File In Section: Product Recalls  
Bulletin No.: 09047  
Date: April 2009

## PRODUCT SAFETY RECALL

**SUBJECT:** Engine Compartment Fire

**MODELS:** 1997-2003 Buick Regal  
1998-1999 Chevrolet Lumina  
1998-2003 Chevrolet Monte Carlo  
2000-2003 Chevrolet Impala  
1998-1999 Oldsmobile Intrigue  
1997-2003 Pontiac Grand Prix  
Equipped with 3.8L V6 Naturally Aspirated Engine (RPO L36 – VIN K)

2257341

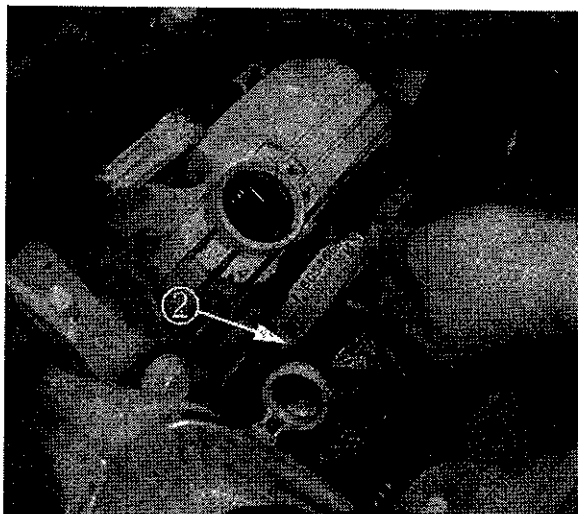
**Important:** Ensure the installed spark plug wire retainers do not contact the fuel injector sight shield or exhaust manifold.

5. Install the fuel injector sight shield (1). Refer to *Fuel Injector Sight Shield Replacement* in SI.

2257354

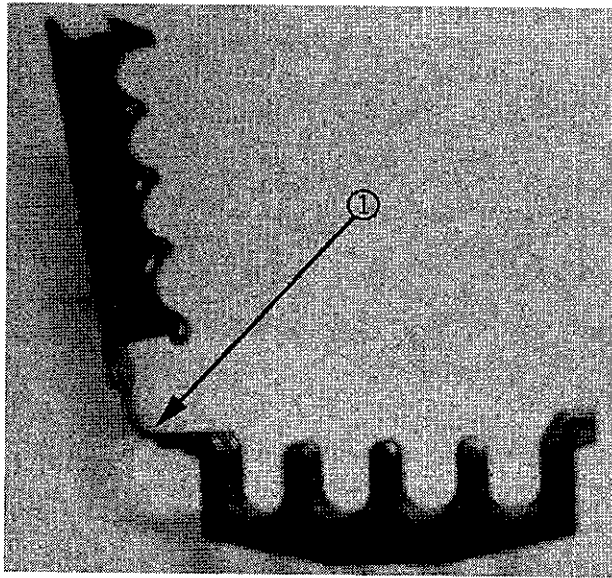
2. Remove the 1-3-5 spark plug plastic retaining channel (cover) clip/bracket (2) from the engine and discard it.

2257359

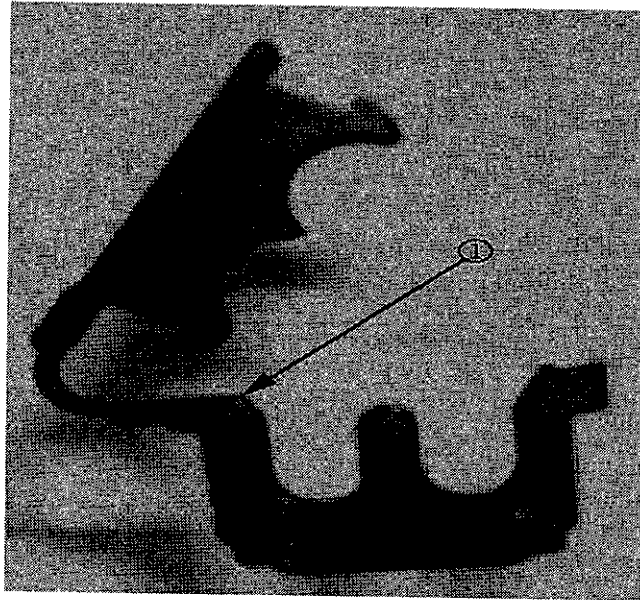
3. Install a 7 mm four-wire retainer, P/N 88891792 (1) (qty 5/pack) to spark plug wire number 4, then to spark plug wires 1, 3 and 5. Save the other 7 mm or 8 mm spark plug four-wire retainers for future repairs. Make sure that spark plug wires 2, 4 and 6 are secured to the original retainers and under the left engine mount strut bracket (2).

2257363

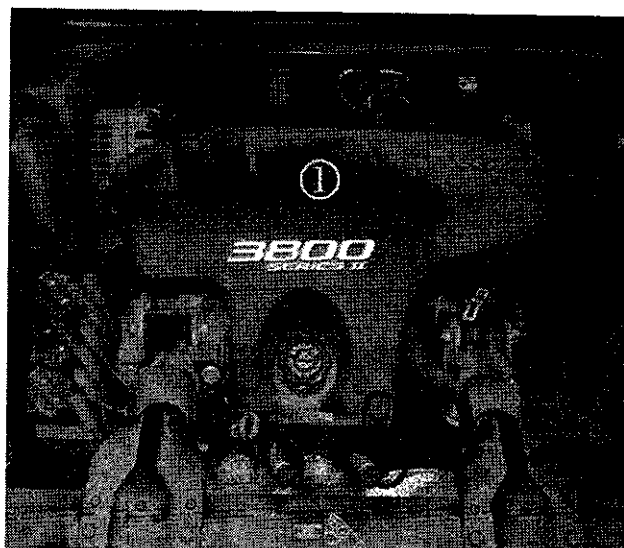
4. Install a 7 mm two-wire retainer, P/N 12132229 (Qty 10/pack) to spark plug wires 3 and 5 only (3). Save the other 7mm spark plug two-wire retainers for future repairs. Make sure the spark plug retainer (3) is approximately 50 mm (2 in) from the oil level indicator (2).
